Well Name: CANYON LARGO UNIT	Well Location: T25N / R6W / SEC 7 / NESW / 36.410446 / -107.511566	County or Parish/State: RIO ARRIBA / NM
Well Number: 61	Type of Well: CONVENTIONAL GAS WELL	Allottee or Tribe Name:
Lease Number: NMSF078883	Unit or CA Name: CANYON LARGO UNIT--PC	Unit or CA Number: NMNM78383A
US Well Number: 3003923820	Operator: HILCORP ENERGY COMPANY

Notice of Intent

Type of Submission: Notice of Intent	Type of Action: Plug and Abandonment
Date Sundry Submitted: 05/03/2024	Time Sundry Submitted: 11:54
Date proposed operation will begin: 05/23/2024

HILCORP ENERGY COMPANY
CANYON LARGO UNIT 61
P&A NOI

CANYON LARGO UNIT 61 - PROPOSED WELLBORE SCHEMATIC

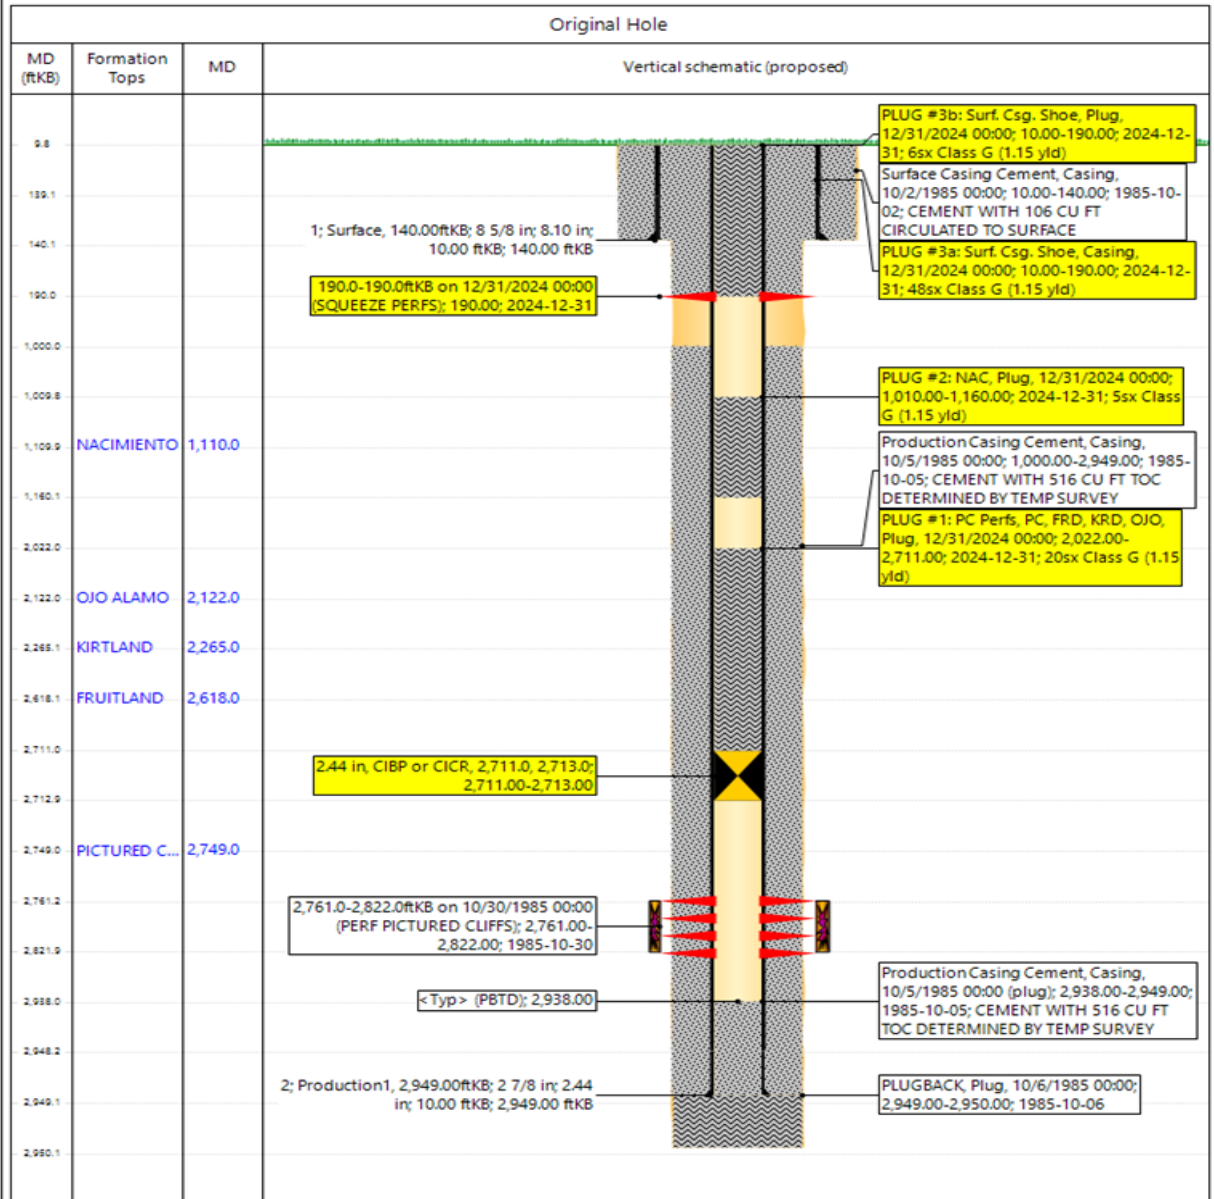
The available induction log and the reference wells support the formation tops selected by the operator up to Ojo Alamo. The Nacimiento top appears to be higher than the operator selected location. Adjust the top of Plug 2 to 750 ft to account for the BLM selected Nacimiento top at 850 ft.	Canyon Largo Unit 243 US Well No. 30-039-20899 Sec 14 T 25N R 7W Rio Arriba County, New Mexico Canyon Largo Unit 452 US Well No. 30-039-27018 Sec 12 T 25N R 6W Rio Arriba County, New Mexico
--	--

1. Plugging operations authorized are subject to the attached "General Requirements for Permanent Abandonment of Wells on Federal and Indian Lease."
2. The following modifications to your plugging program are to be made:
 - a. Adjust the top of Plug 2 to 750 ft to account for the BLM selected Nacimiento top at 850 ft.
3. Farmington Office is to be notified at least 24 hours before the plugging operations commence at (505) 564-7750.

Created By	Condition	Condition Date
mkuehling	Notify NMOCD 24 hours prior to moving on -Follow BLM picks for formation tops - Report bradenhead pressure prior to starting plugging - Monitor string pressures daily report on subsequent - extend plug 1 to 50 feet below PC top	5/7/2024
